PROJECT NAME: Galveston Seawall Rip Rap Deficiencies West of 61st Street

SOLICITATION NO: ITB #B211026

RE: ADDENDUM #1

SHEET 2 OF 39

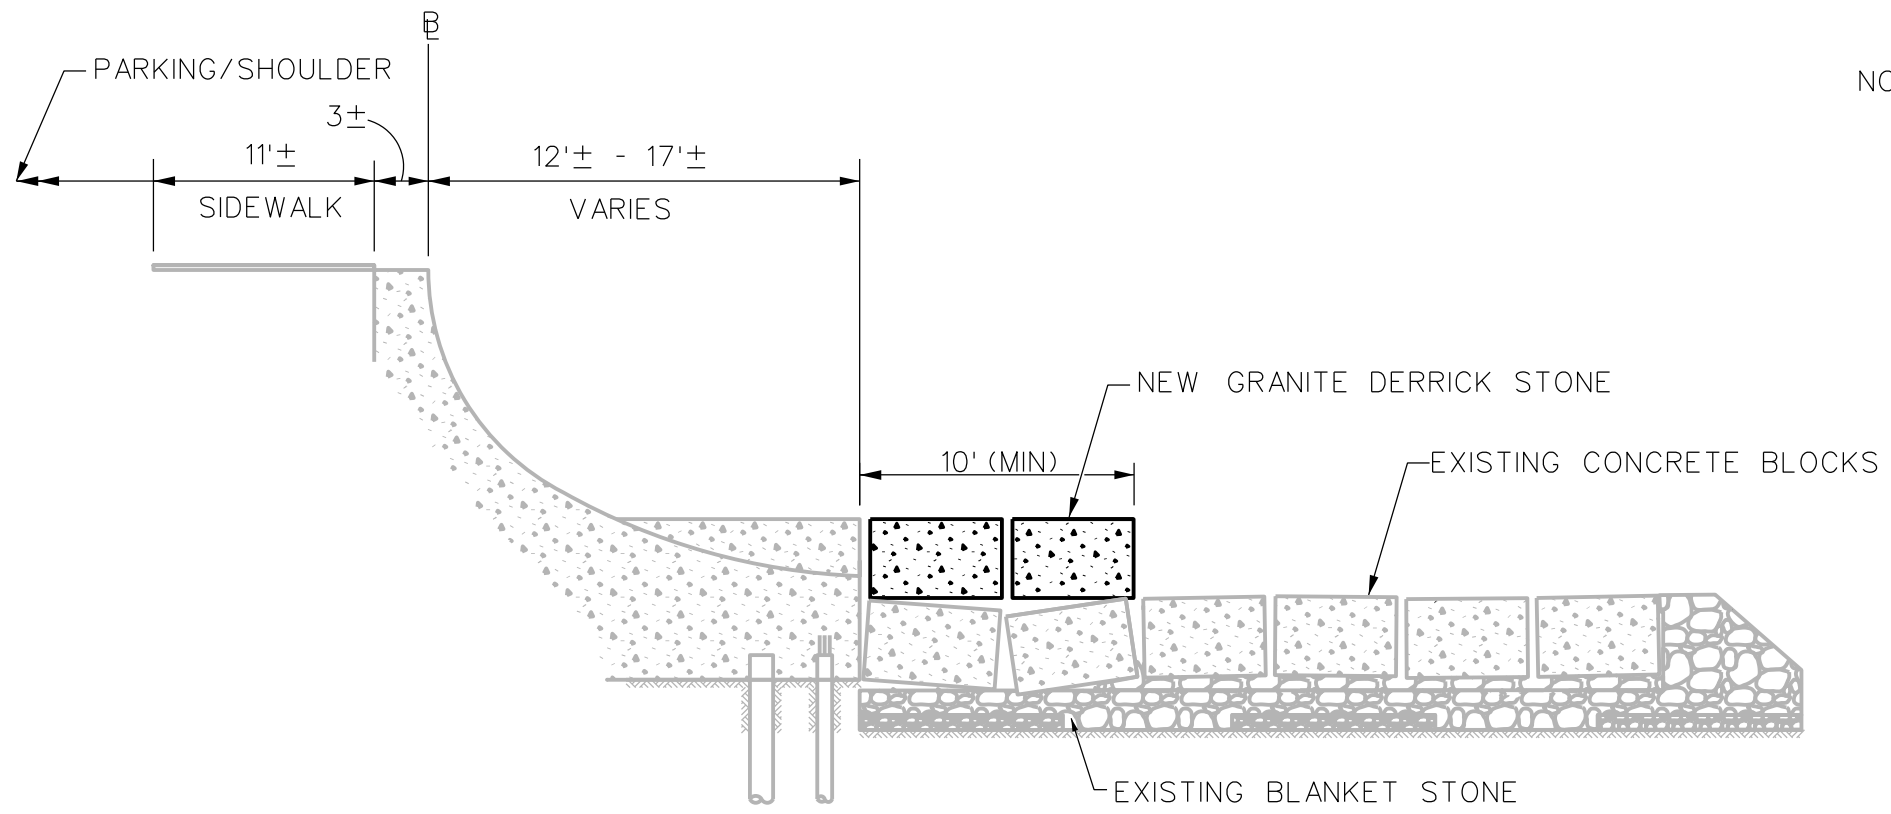
Question #1: *Sheet 2 of 39 states, "No part of the crane including the outriggers shall be placed on the existing sidewalk. Only a rubber-tired crane will be permitted." Are outriggers allowed to be used on the street?*

Question #12: *Per plan sheet 2: please advise as to what permits and licenses will be required by the C.o. Galveston.*

Question #13: *Per plan sheet 2: per 1 column, 7th paragraph; please advise as to the comment: "no equipment on the existing toe". Per a site visit and sheet no. 3; the drawing referencing typical section A show a level across the top of the proposed 6 ea. blocks. Without adding level of bedding rock, stacking the blocks on the existing material will not result in a +/- level top between from 1st through 6th block. If the level up bedding material is incidental; clarification is critical to identify the scope of the project.*

Question #16: *Per plan sheet 2: the second column, second paragraph mentions a pre con meeting requirement to show plan to secure the project site and suspend work due to a forecasted storm event. Further in second column, 4th paragraph mentions “no significant traffic generator events have been identified”. Please clarify if work might be suspended for tourist season or i.e. “Bicker Weekend” or any tourist event that may require a temporary demobilization or traffic control take down and re install.*

Question #17: *Per plan sheet 2: 2nd column, 7th paragraph mentions “120 day installation period will not be added to”. Can the applicable traffic control plan and installation be scheduled just prior to the block arrivals? It is recommended that the existing traffic not be an inconvenience to the public until it is required, and the overall traffic control is and expensive item. Please consider and clarify.*

Question #22: *Sheet no. 2: General notes / left column, 5th paragraph: “procure permits and licenses which are to be issued by the city, county or M.U.D”. At top of middle column, 1st paragraph: “the work fall under the maintenance and repair section of the permit associated with U.S. Army Corps of Engineers (USACE) permit area. Therefore, no additional permits are required.” Please clarify duty of the contractor.*

Question #23: *Sheet no. 2: middle column 5th paragraph down: “The anticipated construction duration after derrick stones begin to arrive at the project sited is 120 calendar days. Construction is limited to daylight hours only”. In the 17th paragraph down / middle column; “use of cones for daylight time work only. Replace cones with plastic barrels during night time hours. Please clarify if night time hours work is allowed.*

Response: Outriggers will be allowed to be used on the street with proper matting. Outriggers must not be placed on the sidewalk no matter what type of matting is used.

Response: This project falls under the maintenance agreement and no federal, county or state permits (other than the TxDOT traffic control approval) are required. The City of Galveston will require a permit.

Response: No leveling is required. The new blocks will be placed on top of the existing surface as neatly as conditions will permit.

Response: There is no anticipated suspension of work for special events. If the City demands a suspension of work, this will be discussed and possibly handed in a change order.

Response: Yes, the 120 days is after the block begins to arrive on site. The schedule has 60 days built into it to allow for production of the blocks. The overall construction duration is 180 calendar days. The traffic should not be impacted until the contractor is ready to place the blocks. Refer to page 85 of the specifications.

Response: This project falls under the maintenance agreement and no federal, county or state permits (other than the TxDOT traffic control approval) are required. The City of Galveston will require a permit.

Response: No nighttime work is permitted. The traffic control will be as shown and approved by TxDOT.

SHEET 3 OF 39

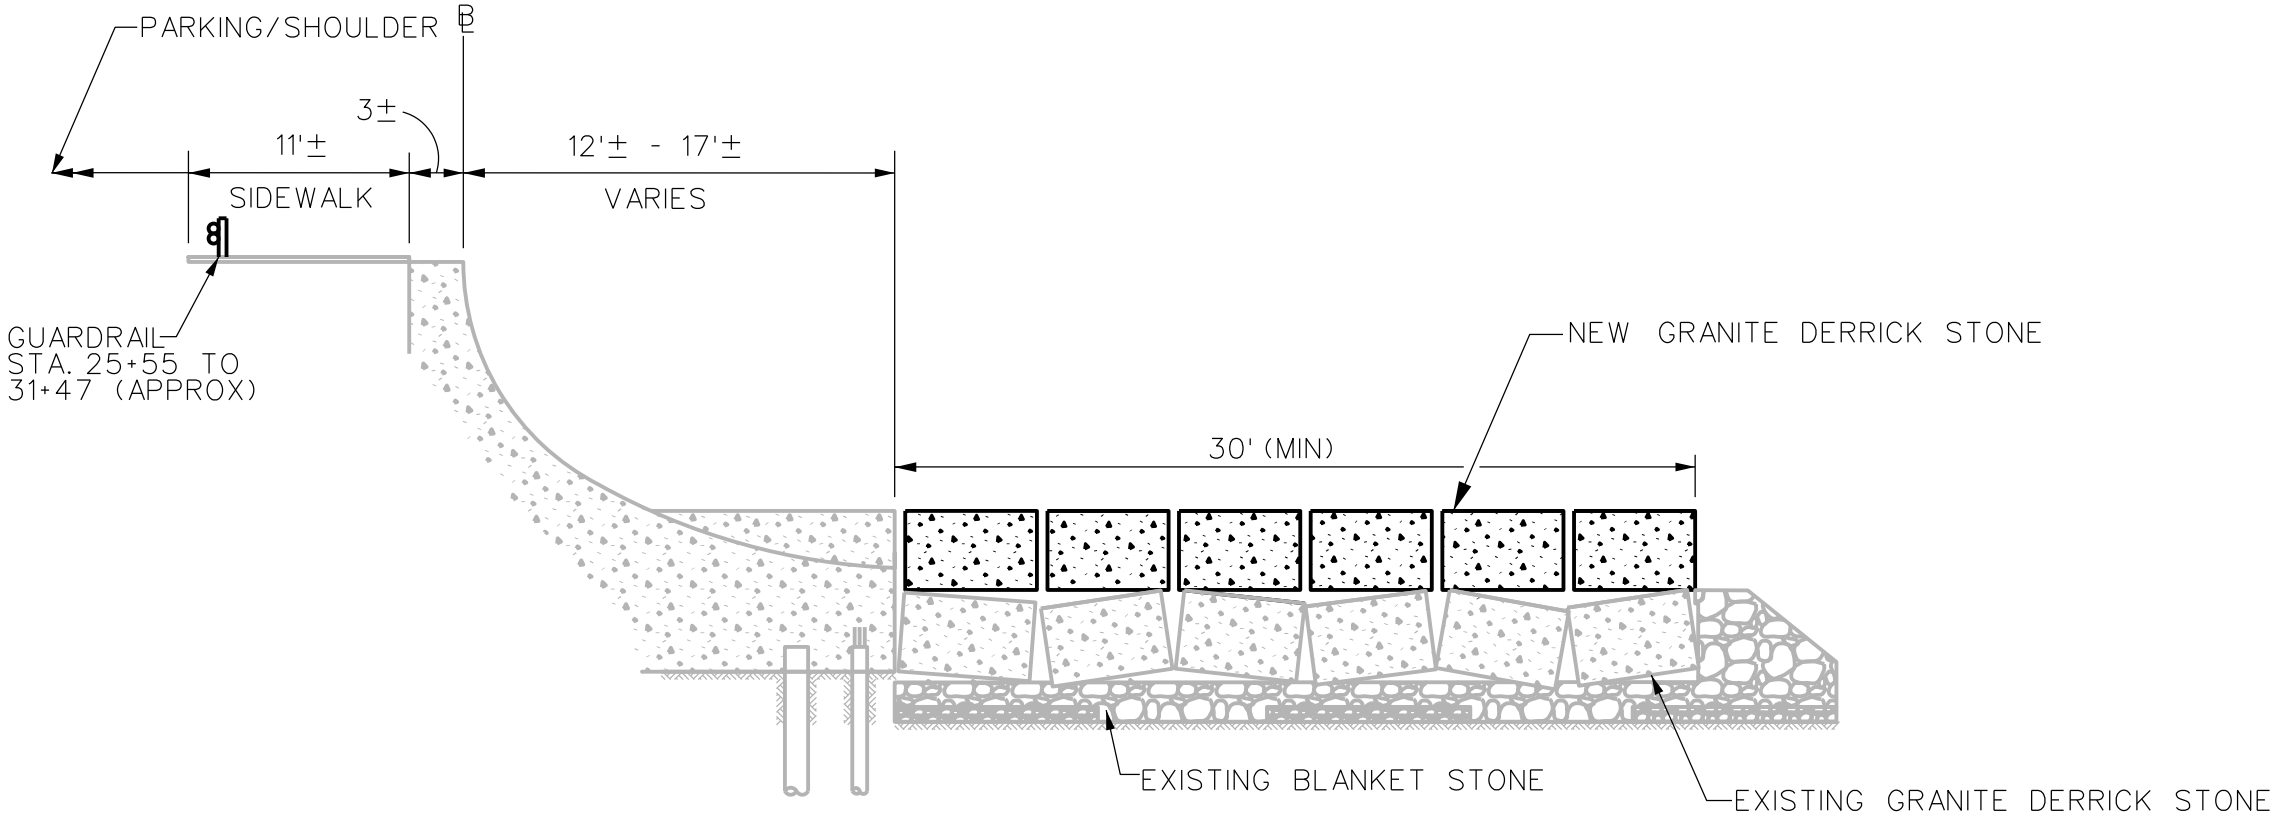
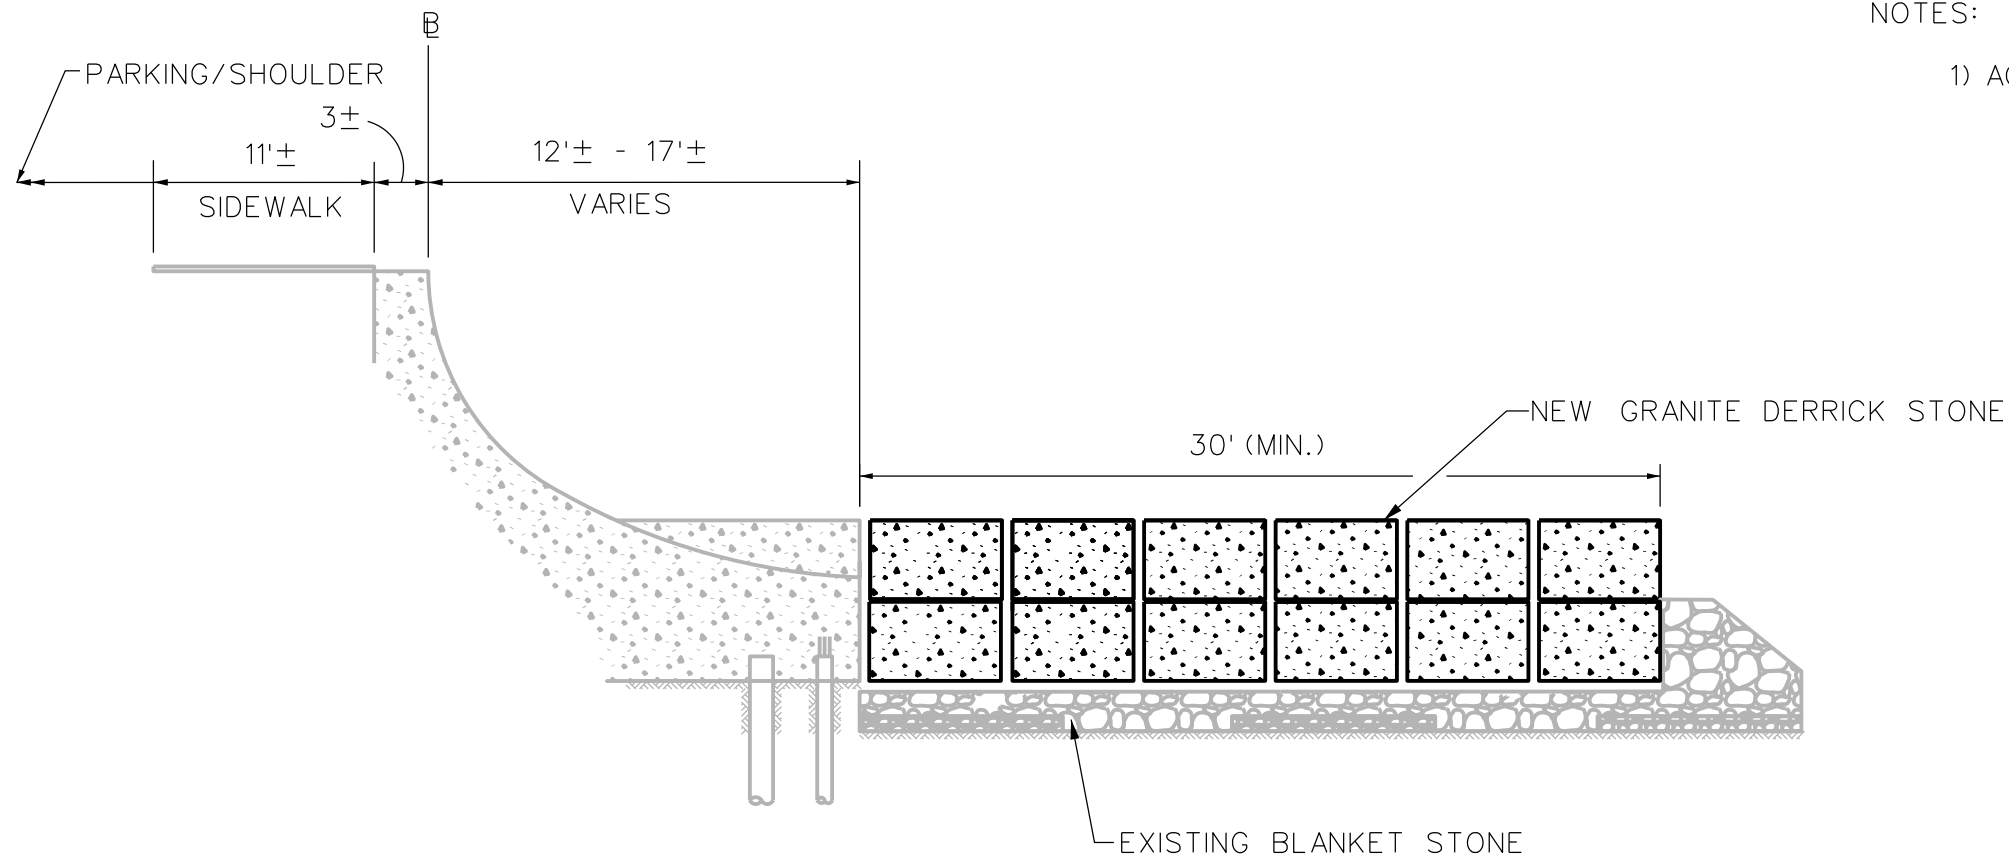
Question #19: *Per plan sheet 3: Regarding note @ top right of sheet; actual field conditions vary significantly more than “slightly”. Please acknowledge.*

Response: Concur, the new blocks will be placed on top of the existing surface as neatly as conditions will permit.

SHEET 5 OF 39

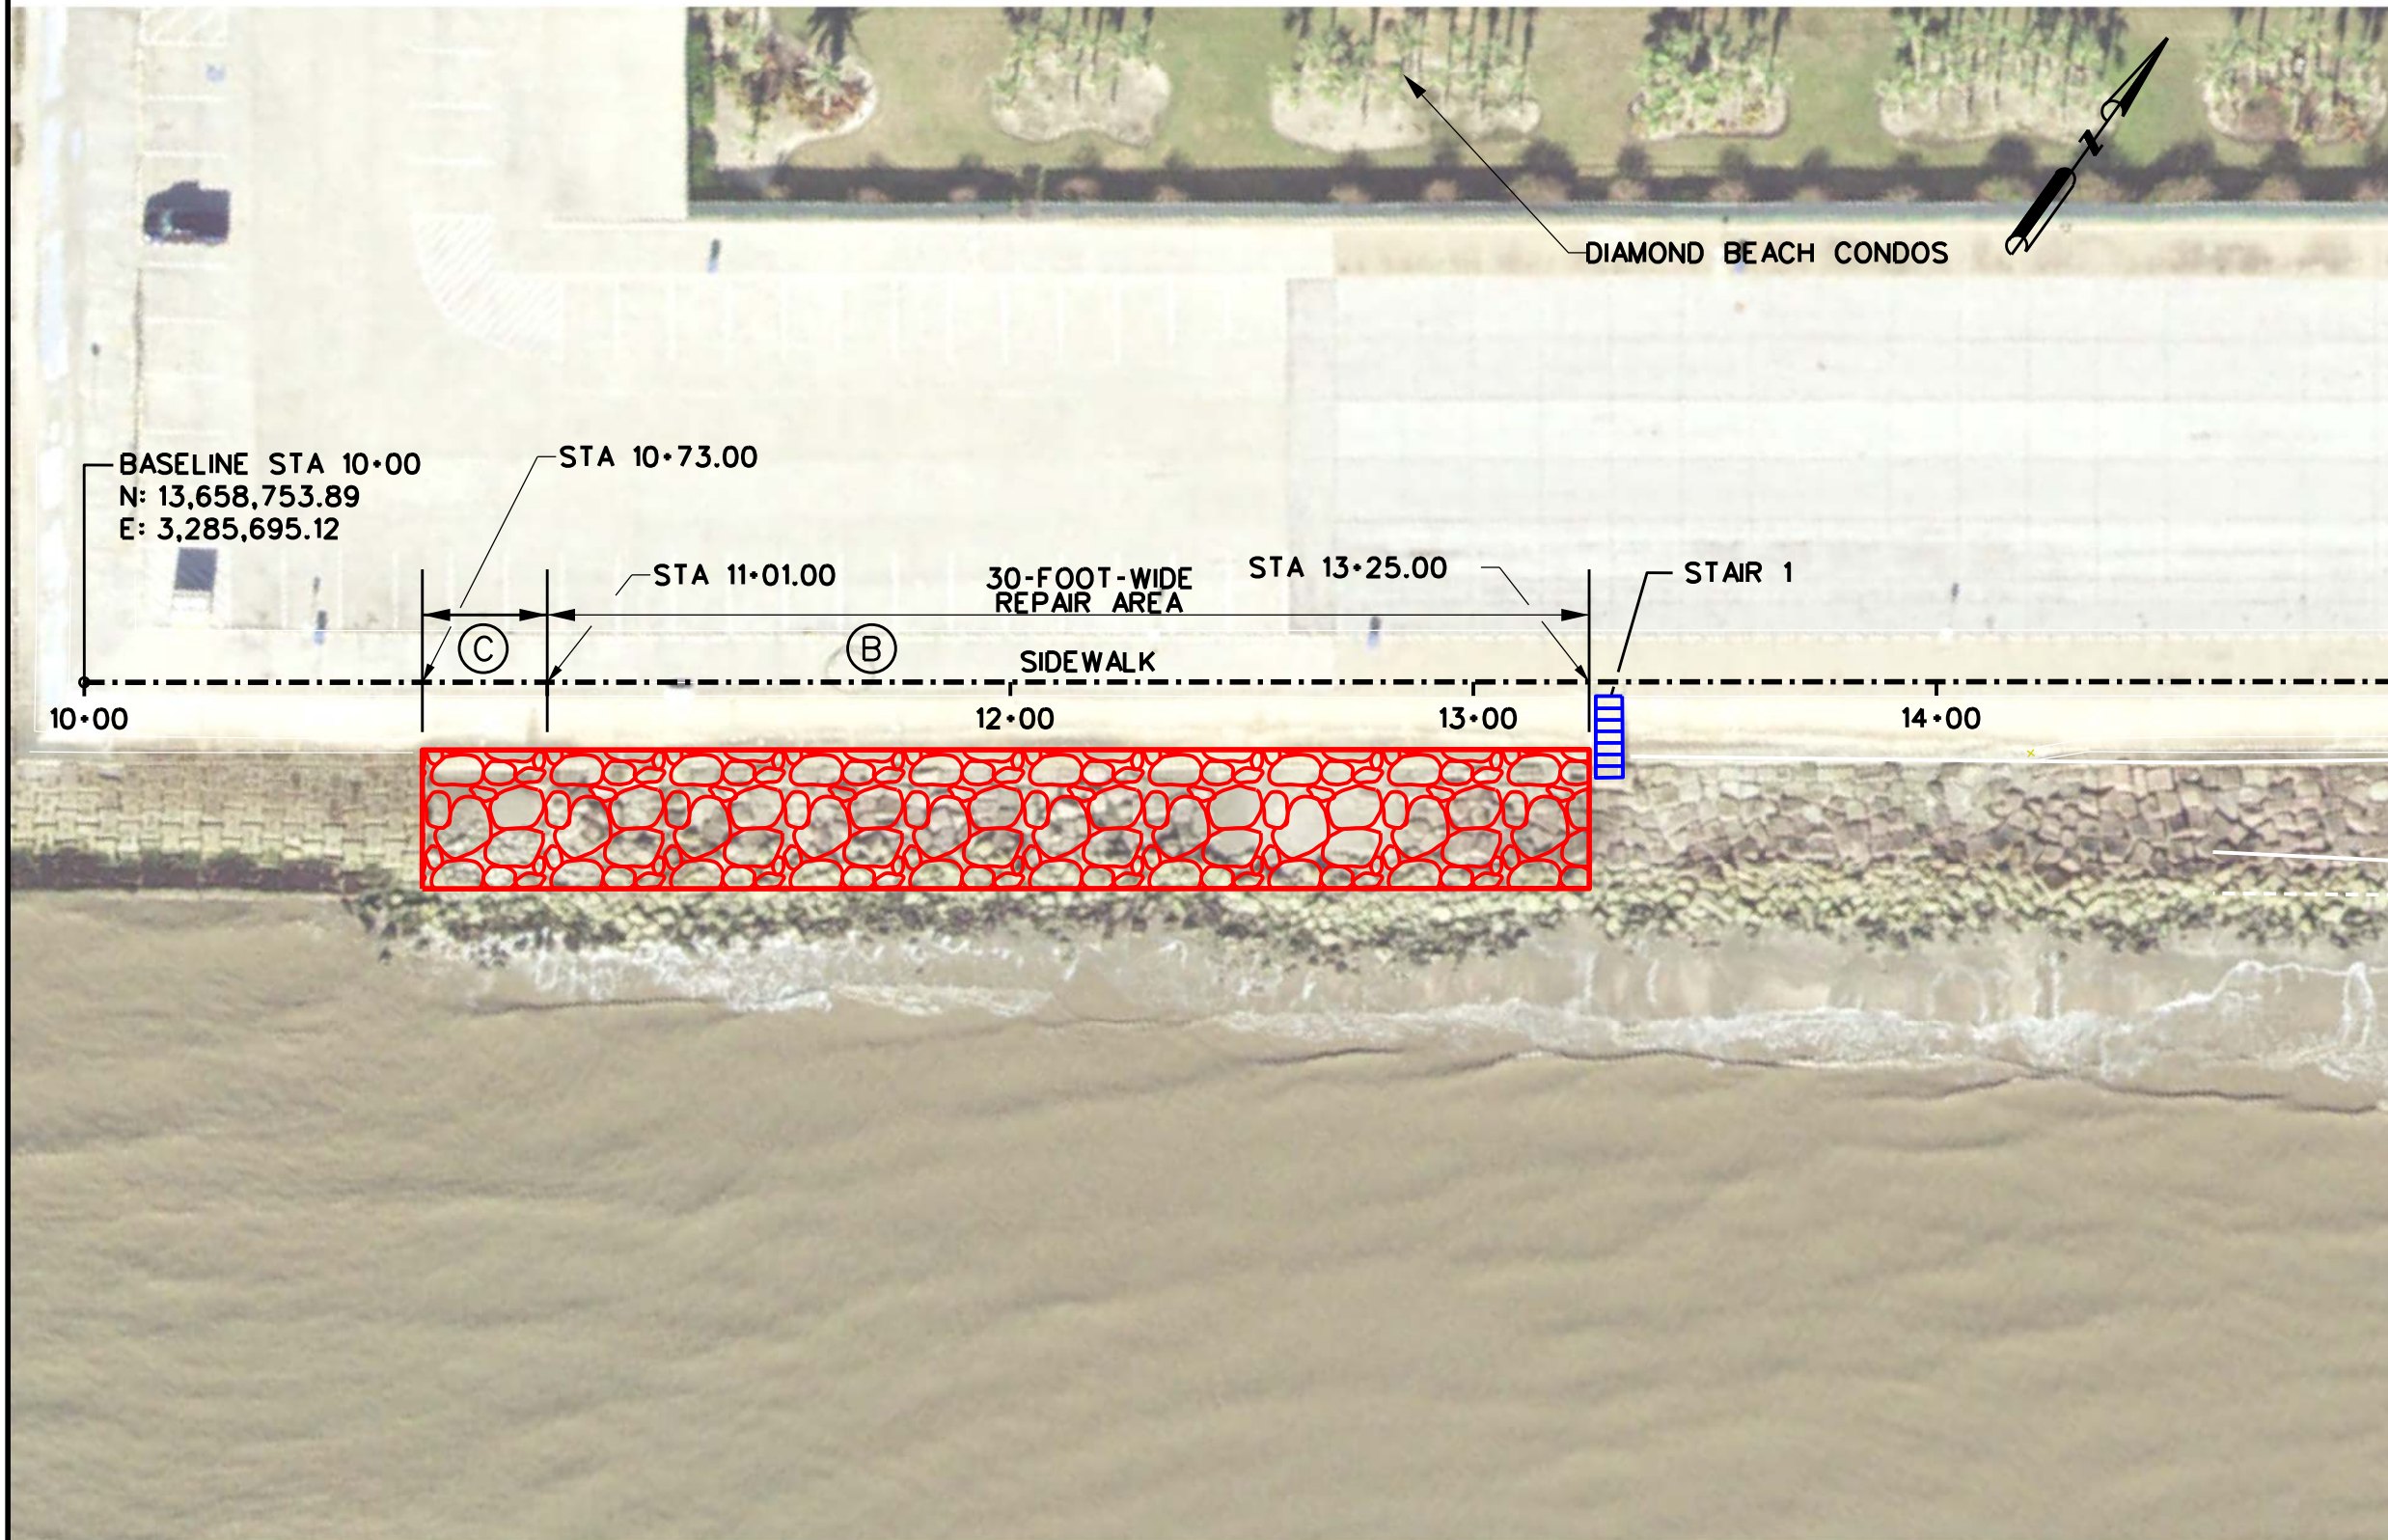
Question #20: *Per plan sheet no. 5: does the 1st block section start @ sta. 10+75?*

Response: The plans call out 10+73 but since this run of blocks goes to the stairs, we would recommend working from the stairs back to the beginning.
